FAP ROUTE 112: IL 53 (RUBY STREET)  
 OVER DES PLAINES RIVER  
 SECTION: M-BDR-1  
 BRIDGE REPAIR  
 WILL COUNTY  
 C-91-115-04

Rev. 9-13-11

Sheet added 09/12/2011 VHV

F.A.P. RTE. 112	SECTION M-BDR-1	COUNTY WILL	TOTAL SHEETS 66	SHEET NO. 9A
			CONTRACT NO. 62714	
ILLINOIS FED. AID PROJECT

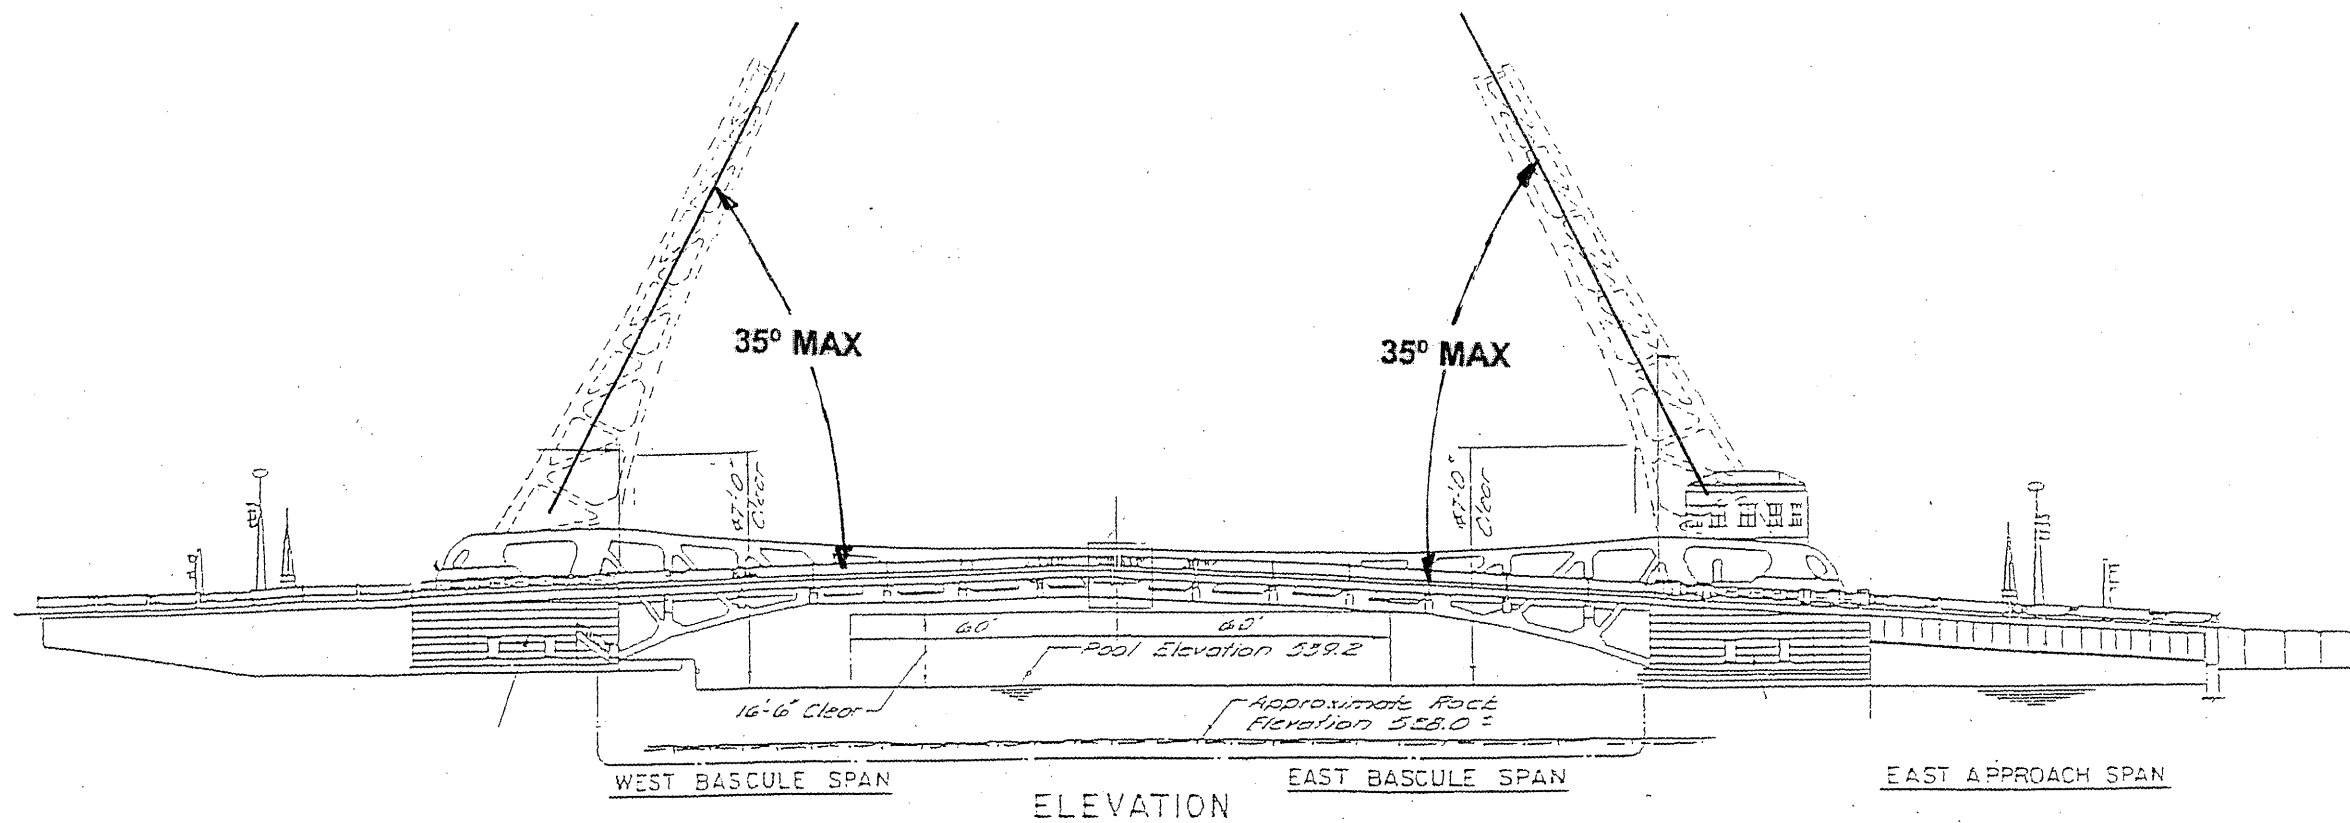
*The maximum raised bridge position for the bridge while it is wrapped for containment during blasting and painting operations is 35°. High speed winds are not permitted when the bridge is raised and covered for blasting and painting which could affect the safety of personnel and the structural integrity of the bridge itself.*

*During any blasting or painting operations when the bridge is contained by tarpaulins or other coverings, the bridge must be closed to the down (0°) position if wind speeds are forecasted by NOAA or other official source to be gusting above 45 mph. Closure to the 0° position shall be accomplished at least one (1) hour before the storm is projected to affect the Joliet area.*

*Blasting and painting can only be accomplished on one leaf at a time. Under no circumstances can the trunnion bearing cap or main pinion shaft removal and replacement (as shown on other sheets in this contract) be performed on the same leaf at the same time as blasting and painting. Each operation must be done separately of the other, and on opposite leaves of the bridge.*

*During blasting and painting, the bridge leaf that is being blasted or painted must be operational.*

**NOTES FOR LUBRICATION AND BEARING REPLACEMENT**

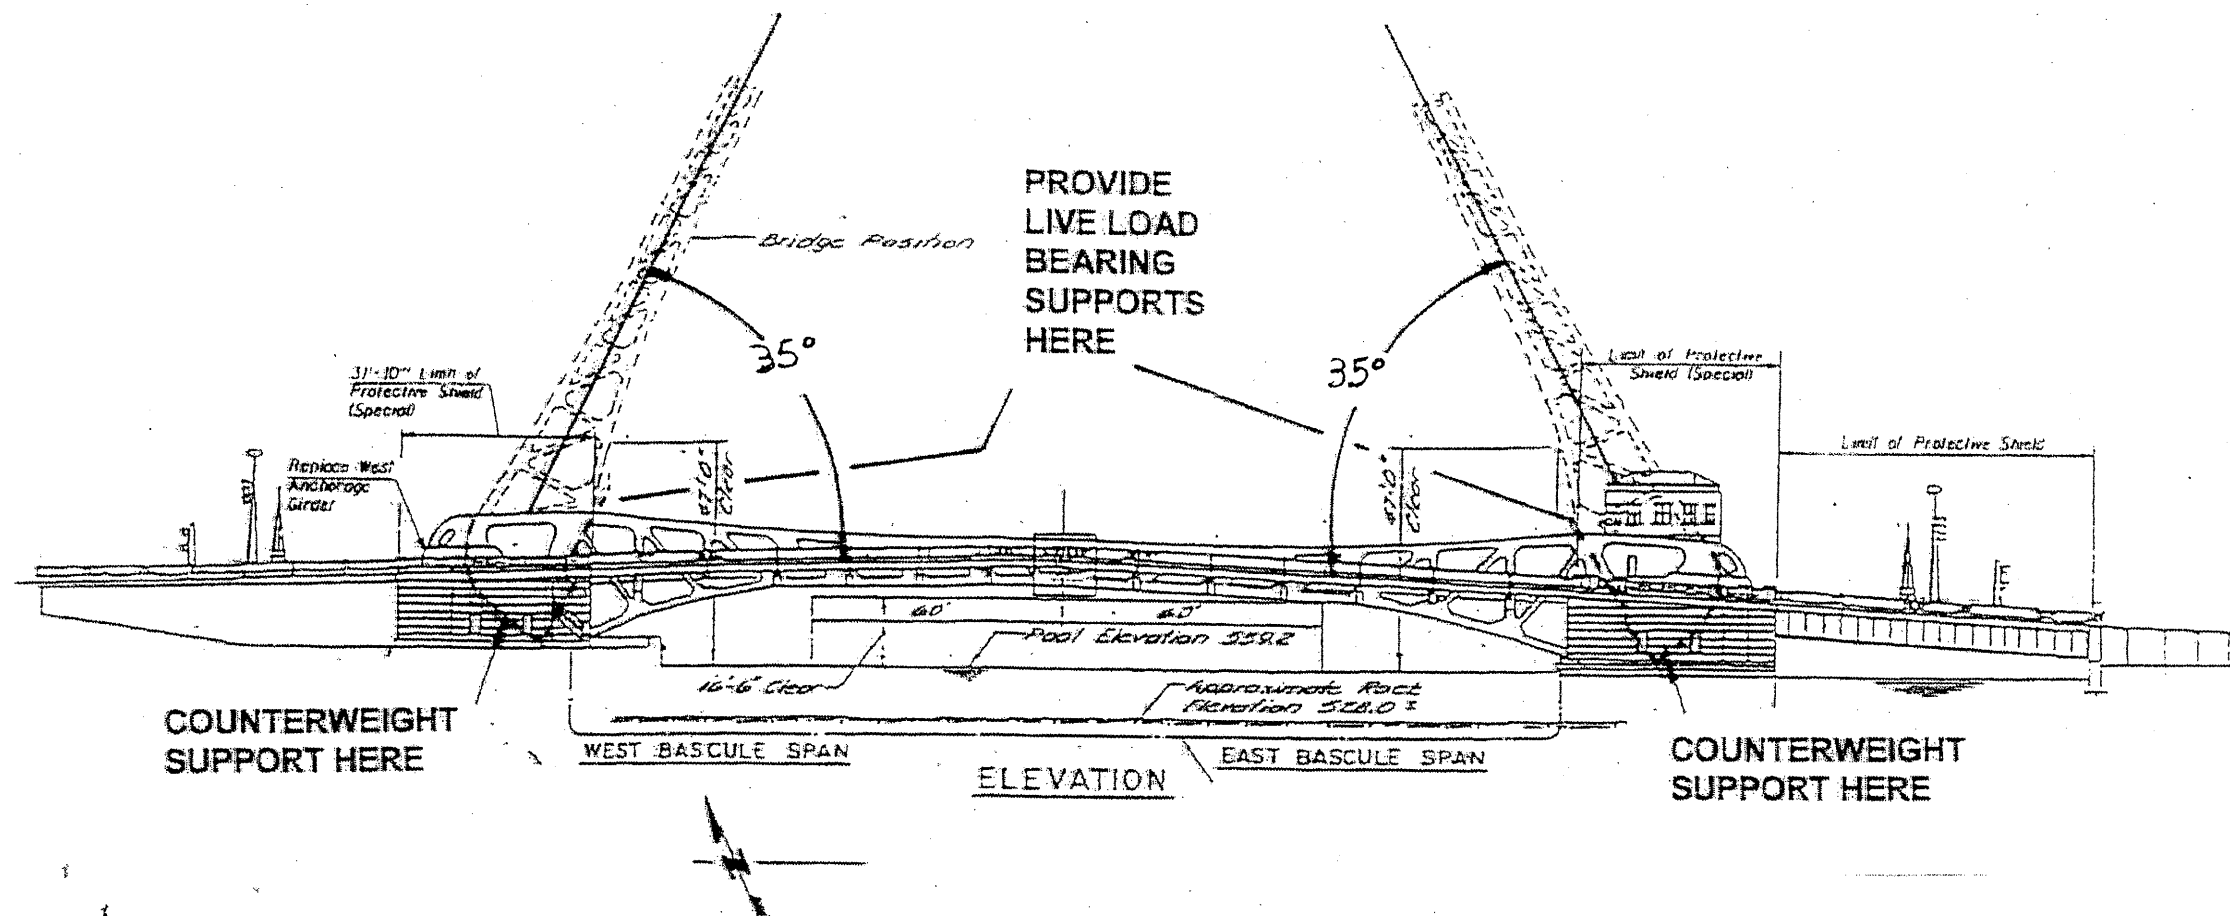
REVISION 09/12/2011 VHV

When trunnion bearing caps are removed for lubrication, or main pinion shafts are removed for main bearing replacements, the bridge shall be locked at a 35° position. See special provision Temporary Support System.

As soon as trunnion lubrication and main bearings and pinion shafts are aligned and installed, the bridge shall be tested for smooth operation, presence of any misalignment, abnormal heating of bearings, grinding or unusual acoustic emissions. Before the contractor makes the bridge leaf fully active again, its operational status shall be subject to the approval of the Engineer.

Work is to be completed on one leaf at a time and under no circumstance in the same leaf that is being blasted and painted.

TEMPORARY SUPPORT SYSTEM REACTIONS AT 35° POSITION  
(for counterweight)

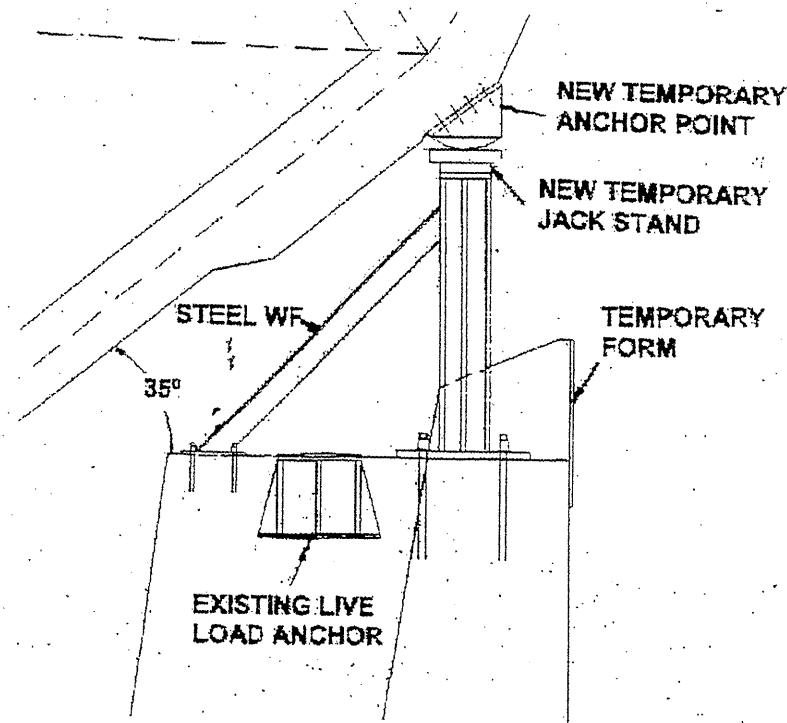
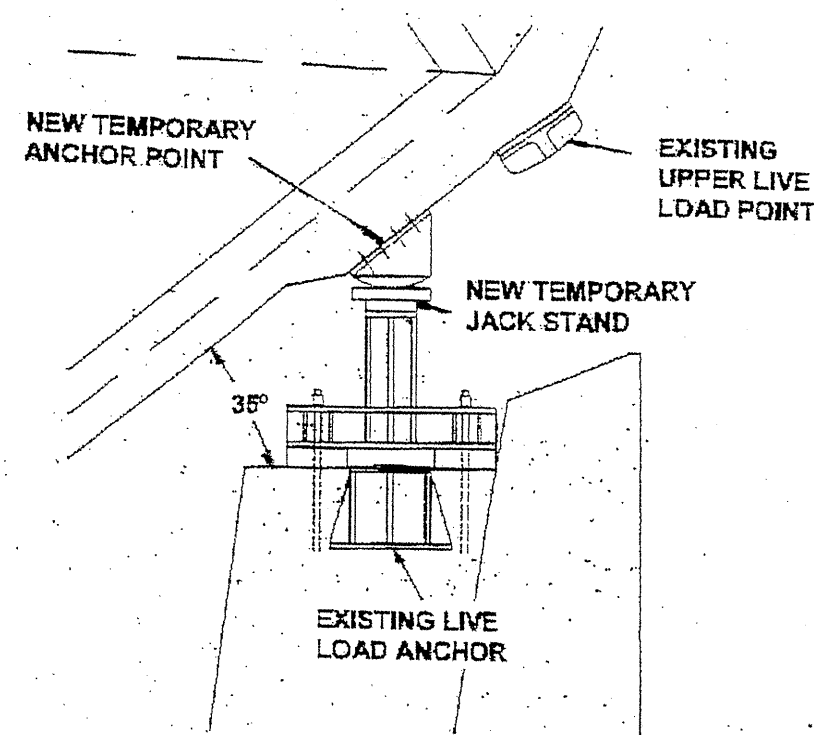
FILE NAME =	USER NAME = mdyje	DESIGNED -	REVISED -	STATE OF ILLINOIS DEPARTMENT OF TRANSPORTATION	RUBY STREET OVER DES PLAINES RIVER SN 099-8901	F.A.P. RTE.	SECTION	COUNTY	TOTAL SHEETS	SHEET NO.
work\p1001\madyje\08148931\011159	whr-plan.dgn	DRAWN -	REVISED -			112	M-BDR-1	WILL	66	57A
PLOT SCALE = 1/8" = 1'-0"	CHECKED -	REVISED -	CONTRACT NO. 62714			ILLINOIS FED. AID PROJECT			ADDED 09/12/2011 VHV	
PLOT DATE = 6/23/2011	DATE -	REVISED -	SCALE:			SHEET NO. OF 30 SHEETS	STA. TO STA.

Two live load bearing supports design are recommended. Alternate No. 1 uses the existing upper live load bearing, with a temporary river wall support. Alternate No. 2 requires strengthening of the attachment point on the structural member to provide better load sharing since it is not in line with principal support points.
